## Planning and Zoning AGENDA

Tuesday, May 19, 2020  
Ketchum City Hall  
480 East Avenue North, Ketchum, ID 83340

4. [ACTION - 3020 Warm Springs Rd. \(Waddell/Roush\) Duplex Design Review: 3020 Warm Springs Rd. \(Wills Condominium Subdivision No. 2\)](#) The commission will hold a virtual public hearing to consider and take action on a Design Review application submitted by architect Craig Lawrence, on behalf of property owners Doug and Stacey Waddell, for the development of a new duplex and associated site improvements within the General Residential Low Density (GR-L) Zoning District.

**STAFF REPORT**  
**KETCHUM PLANNING AND ZONING COMMISSION**  
**MEETING OF MAY 19, 2020**

**WADDELL/ROUSH DUPLEX**  
3020 WARM SPRINGS ROAD, KETCHUM, ID. 83340

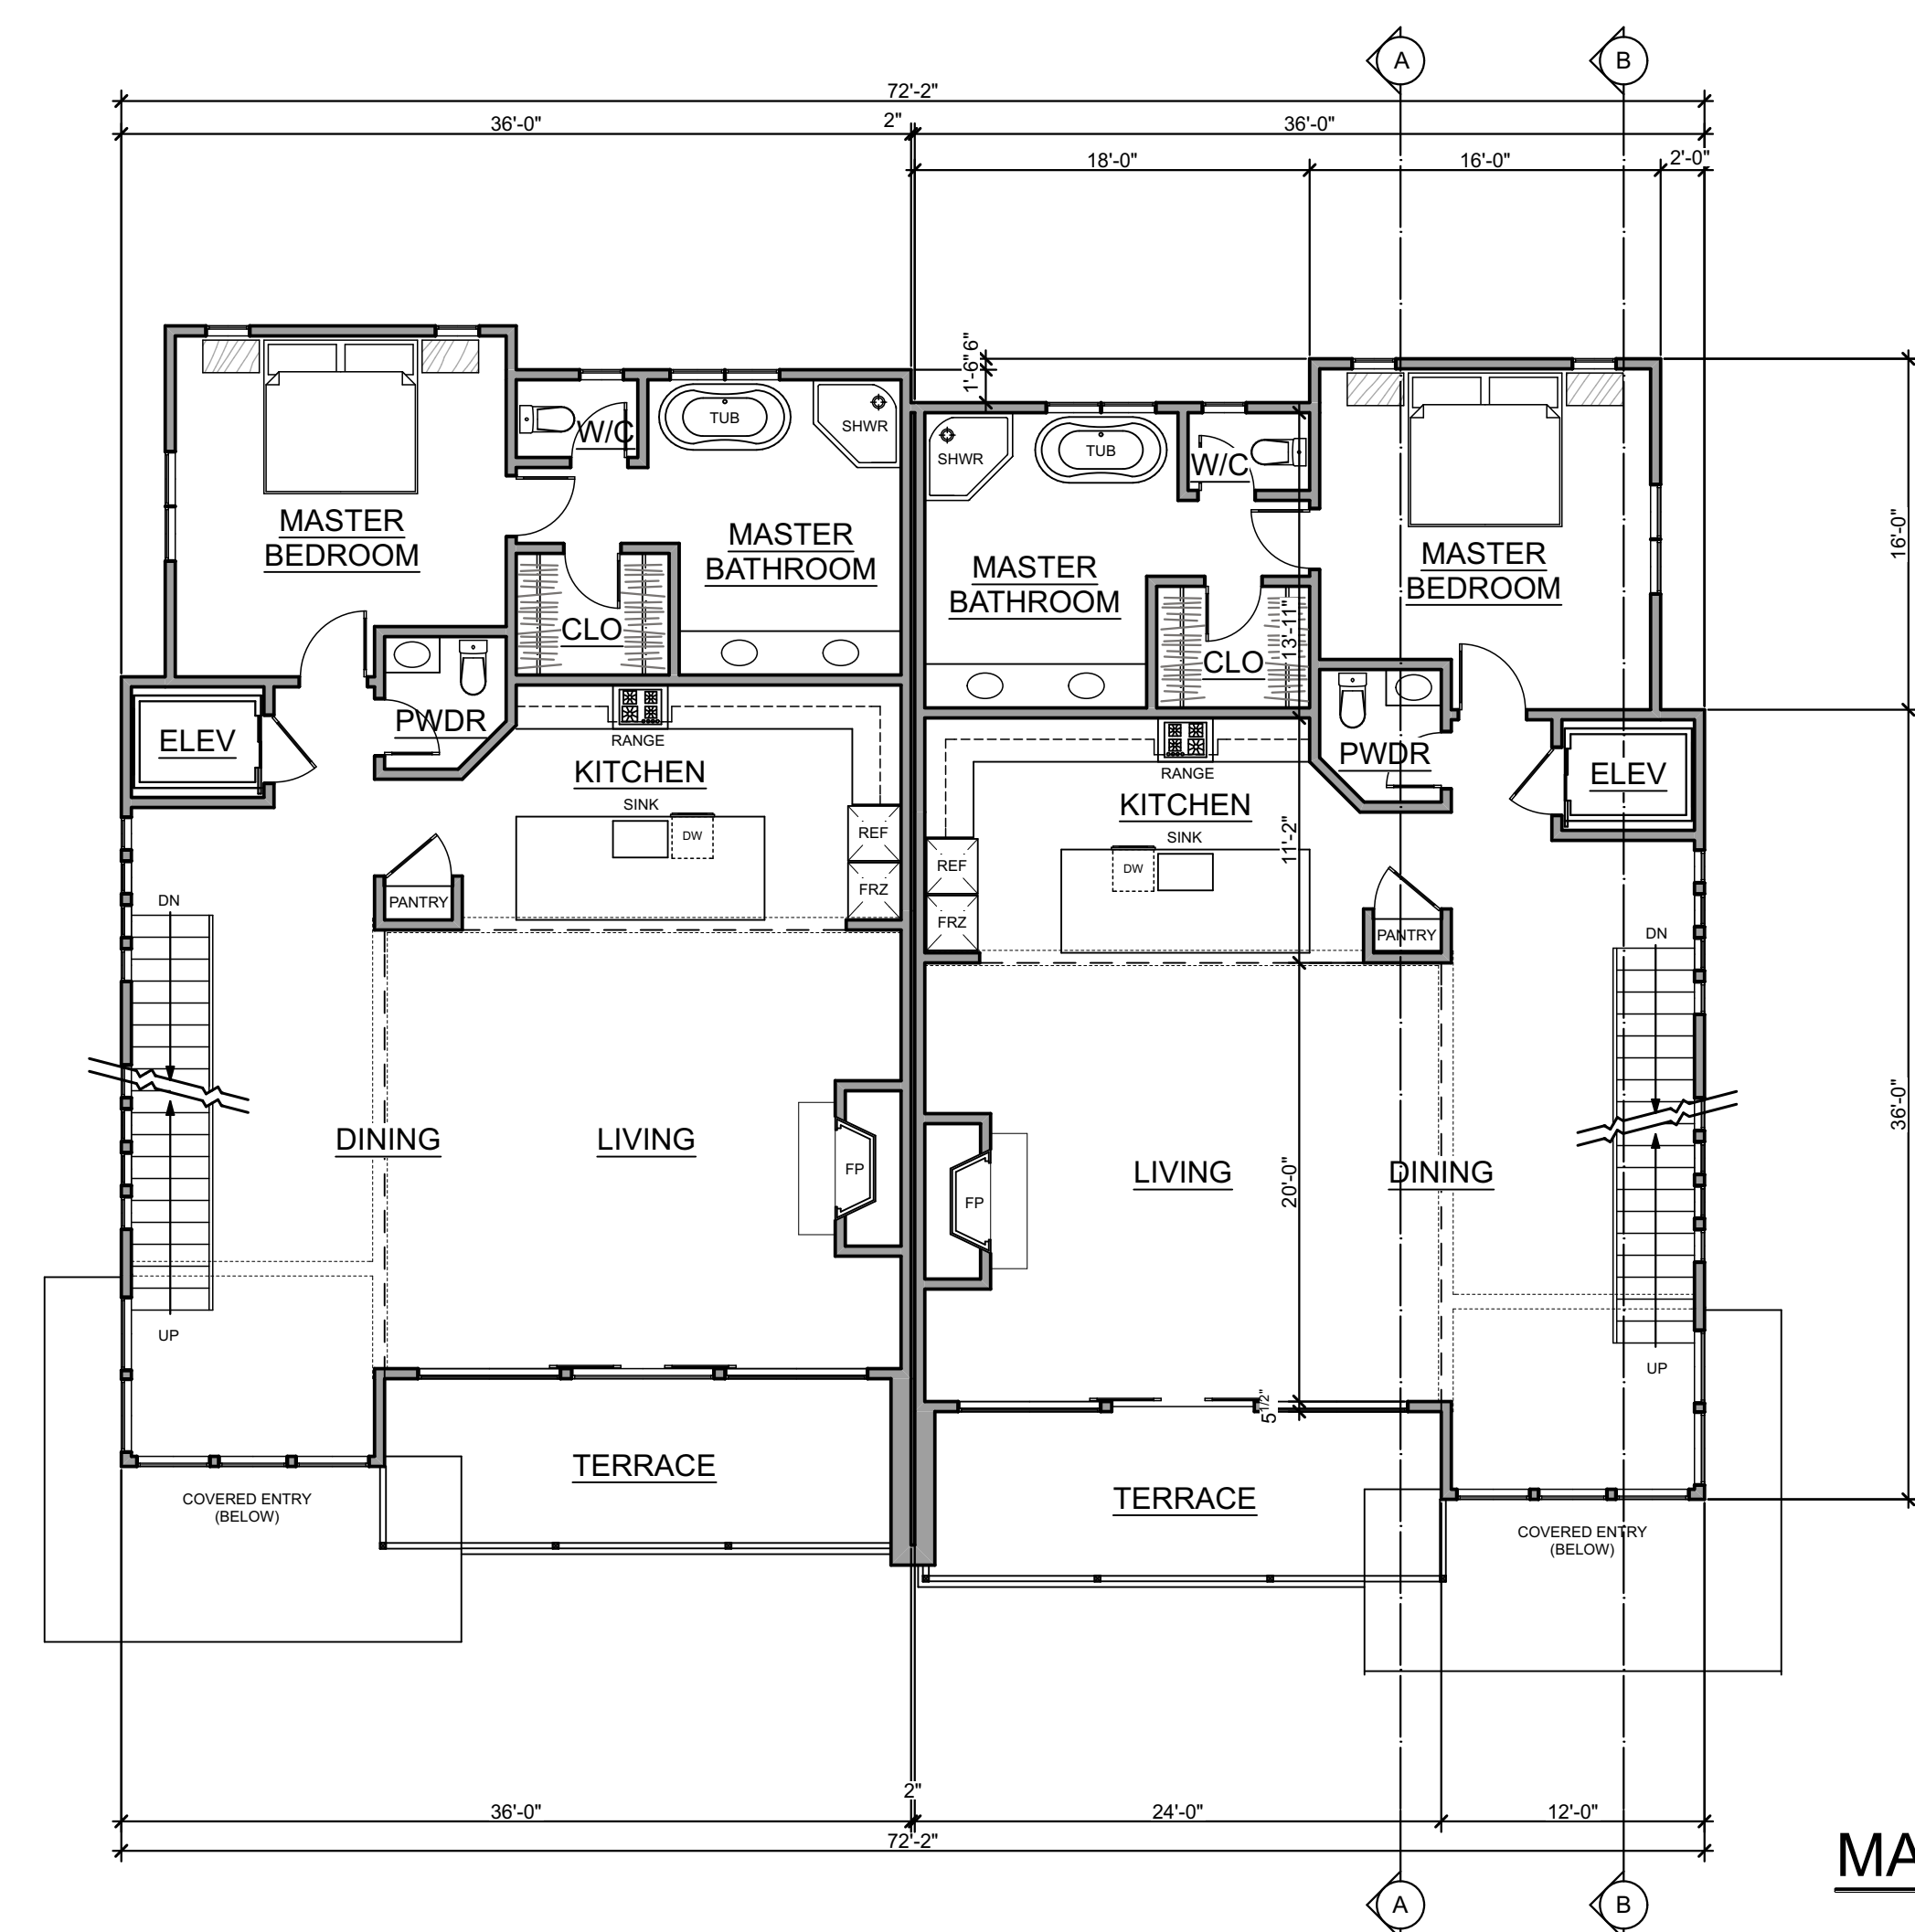
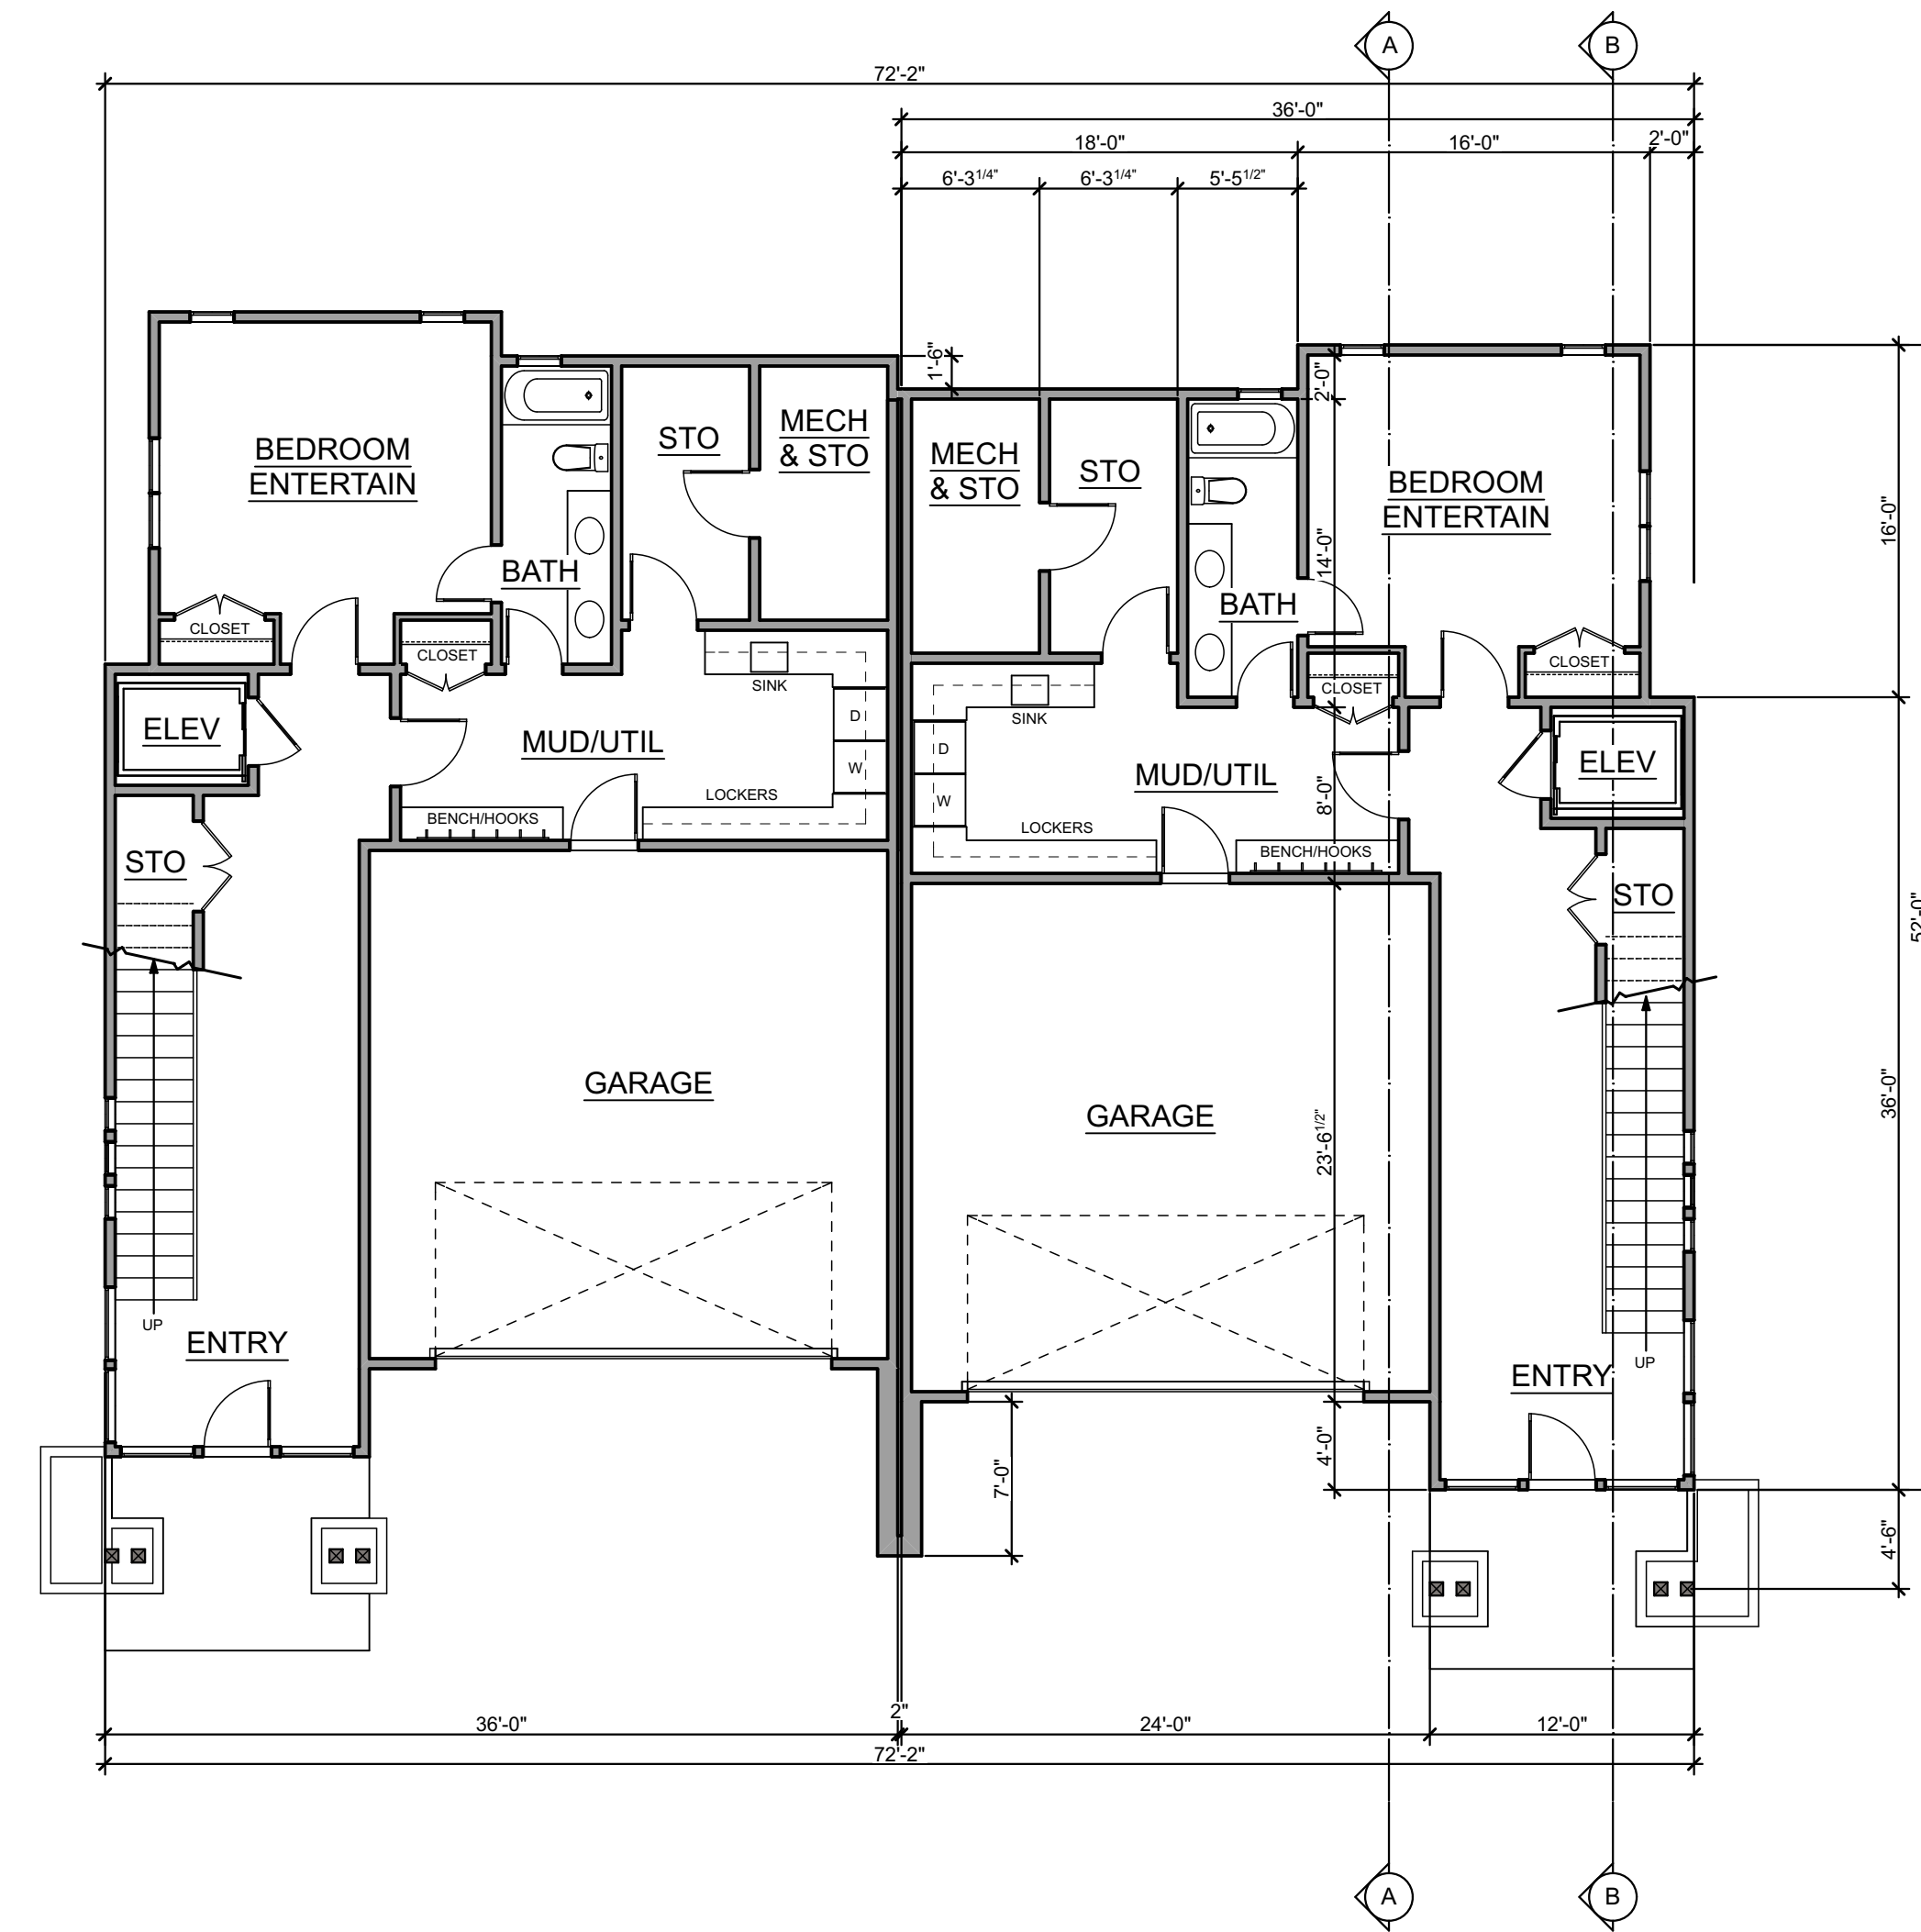
Building elevations are included on Sheets A-03 and A-04 of the project plans. The three floors are horizontally stacked on top of each other as one-story elements separated by a border of black fascia. The lack of sufficient vertical, two- or three-story elements incorporated into the façade design exacerbates the appearance of flatness.
